Archived: Friday, April 17, 2026 10:07:52 AM
From: [Dylan Smith](#)
Mail received time: Fri, 10 Apr 2026 19:15:49
Sent: Fri, 10 Apr 2026 19:12:01
To: [Thalhamer, Todd@CalRecycle](mailto:Thalhamer.Todd@CalRecycle)
Cc: btway@ph.lacounty.gov
Subject: RE: Chiquita Canyon Landfill – TMP Temperature Submittal
Importance: Normal
Sensitivity: None
Attachments: [Corrected Borehole Profiles Six Week Maximum - 3-25-26.pdf](#)

Subject: Re: Chiquita Canyon Landfill – TMP Temperature Submittal

Solid Waste Borehole Maximum Temperature Profiles Over 6 Weeks for 2/12/2026 to 3/25/2026

Temperature Probe
Deviation

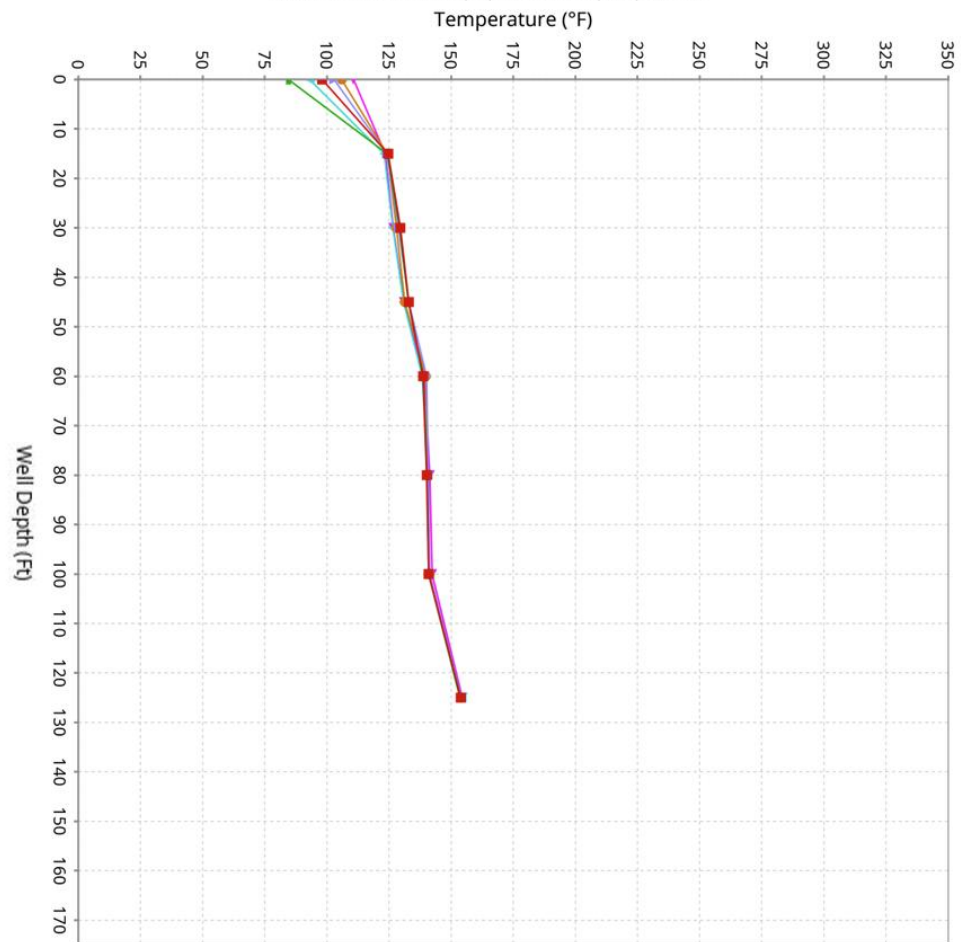
I'm concerned you or SCS Engineers may not be aware of the significant temperature swings in your last TMP submittal, dated March 26, 2026. Given the magnitude of the temperature swings (25 to 40F) at various depths and TPs over six weeks, I assume your graphical TMP submission used incorrect raw data. The prior week, March 18th and newest April 1, 2026 do not show the issue. The following TMPs have temperature issues. See the attached Excel file for details.

TP-1	None
TP-2	None
TP-3	None
TP-4	None
TP-5	None
TP-6	None
TP-7	None
TP-8	None
TP-9	@80ft
TP-10	@80ft
TP-11	@80ft
TP-12	@80ft
TP-13	@75ft
TP-14	@100ft
TP-15	@45ft
TP-16	@60ft
TP-17	@80ft
TP-18	@15ft
TP-19	@100ft
TP-20	@15ft
TP-21	@85ft
TP-22	None
TP-23	@30ft
TP-24	@210ft
TP-25	@90ft
TP-26	@100ft
TP-27	@100ft
TP-28	@120ft
TP-29	@160ft

TP-30 @130ft
TP-31 @180ft

TP-32 @130ft
TP-33 @15ft
TP-34 @90ft
TP-35 @105ft
TP-36 @160ft
TP-37 @130ft
TP-38 @160ft
TP-39 @105ft
TP-40 @160ft

The raw data included in the March 26, 2026 submittal is correct and the temperature swings shown in the graphs submitted on March 26, 2026, are incorrect. During the automated creation of these graphs on March 26, 2026, a network error occurred that caused the graphs to not be based off of the raw data submitted. Correct temperature graphs for this period are attached. Please let us know if you have any additional questions.

Vertical Temperature Profiles from Temperature Probes at Chiquita Landfill for TP-10

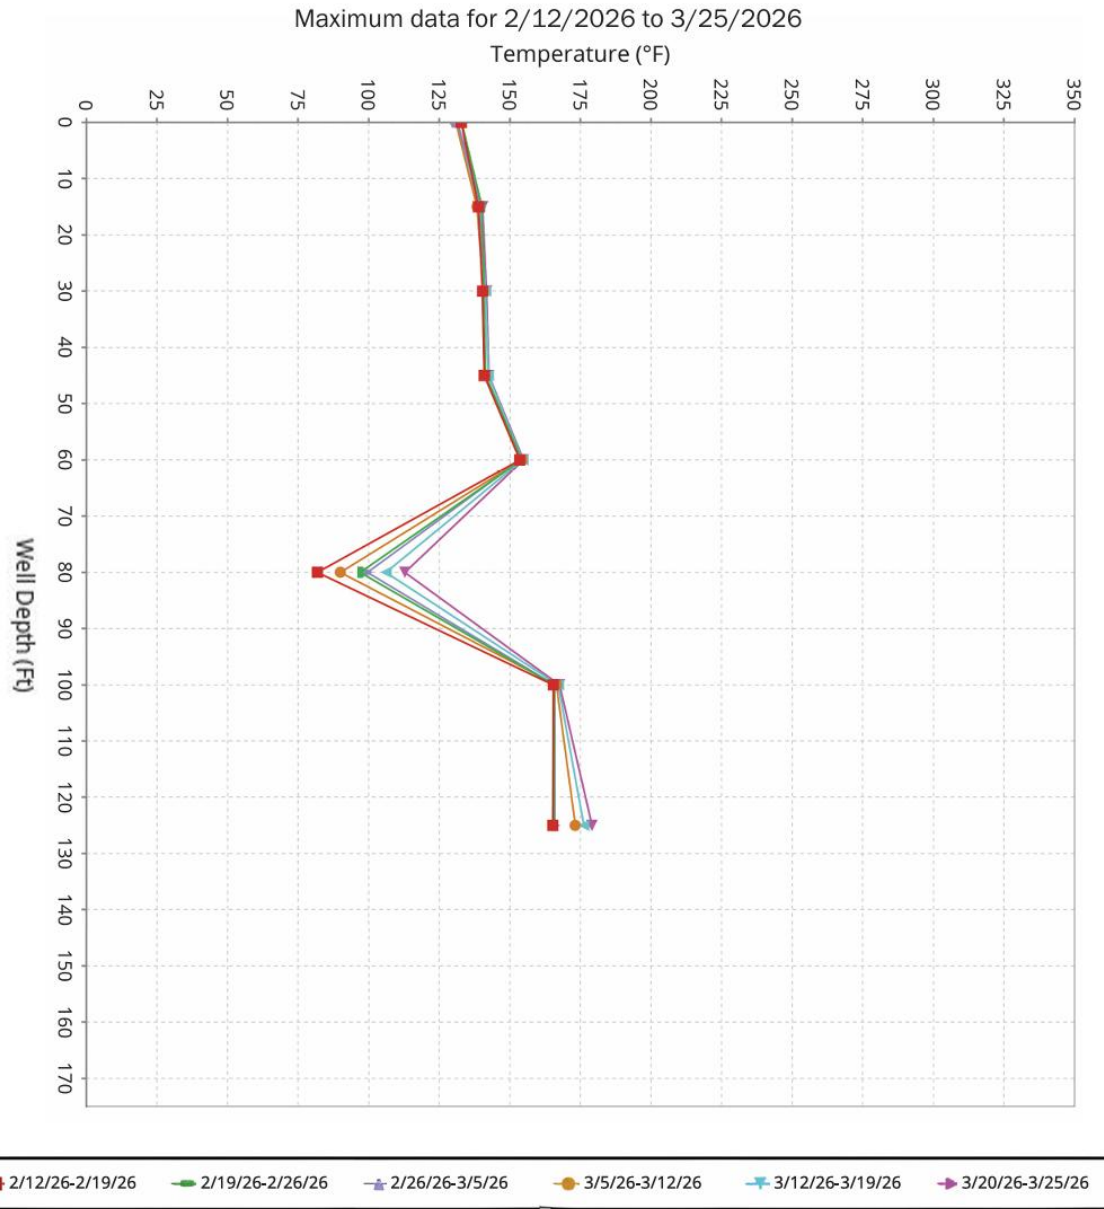
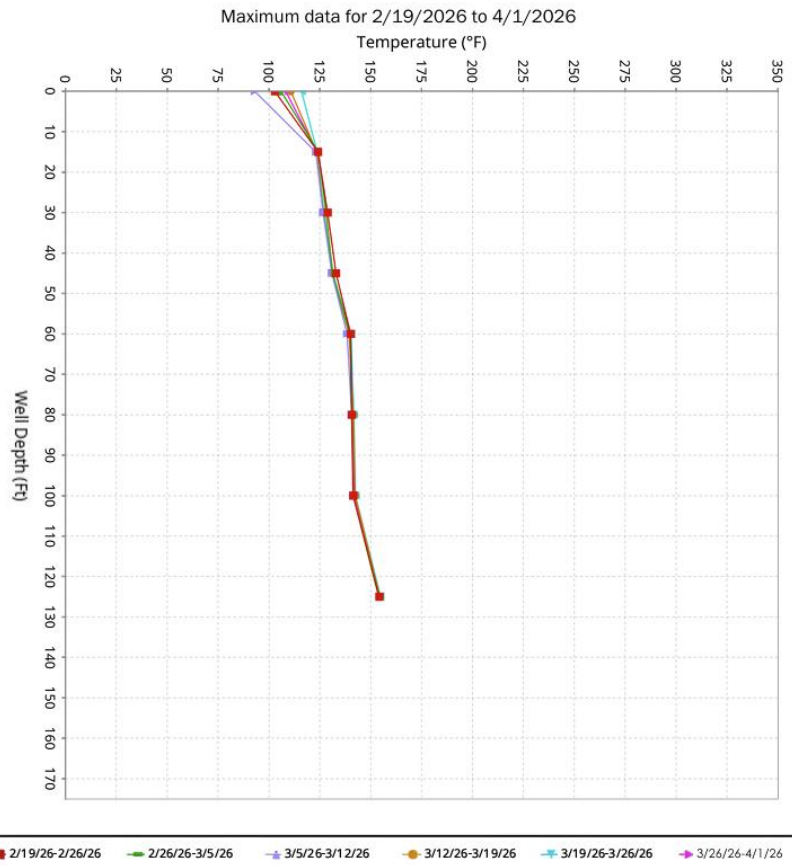
As an example. Looking at TMP 10

March 18, 2026 (No significant temperature swings at 80ft)

These temperature deviations are significant. Please evaluate and resubmit the March 26, 2026, TMP Weekly Report if in error. If not, please contact the LEA as soon as possible and schedule a meeting to discuss the rapid change in temperatures.
